Revised November 2011

Fatigue Piston Cracks on L23/30-series Engines

SL11-541/JXN January 2011

Owners and operators of MAN four-stroke diesel engines.
Type: GenSets L23/30 series

Figure 1

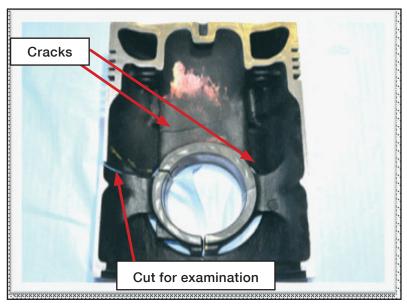
Pistons have been examined and it was found that the cracks originate from the ribs between the pin boss and the intermediate deck.

MAN-L23/30-series engines have proven its reliability and durability over the past decades. Nevertheless, MAN Diesel &Turbo never stopped pouring best efforts to improve the quality of the engines. As one of the results from such efforts, we have found that pistons equipped on L23/30 engines might have fatigue cracks. We have experienced such cracks after 20,000 running hours on few vessels, mainly tankers, which may potentially bring risk and consequential damage to the engine and endanger the health and life of persons who are around the engine.

In order to avoid unfortunate cases, MAN Diesel & Turbo offers a service package consisting of the overhaul inspection and replacement of pistons with reinforced new pistons by improved design. This service package is applicable to L23/30-series engines in service.

Figure 3

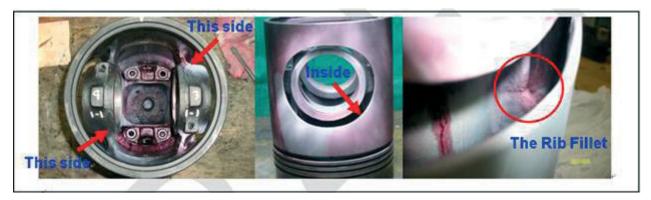
- 1. Lift the piston complete with connecting rod
- 2. Eliminate system oil and impurity on all adjacent area (Fig 3) with cleaning agent
- 3. Spray the liquid penetrant agent (Red) on the fillet and wait for a dwell time (5 min. @ $10\sim52^{\circ}$ C, 10 min. @ $5\sim9^{\circ}$ C)
- 4. Remove the penetrant with the penetrant remover
- 5. Spray the developer (White)
- 6. Inspect whether any hair crack is observed
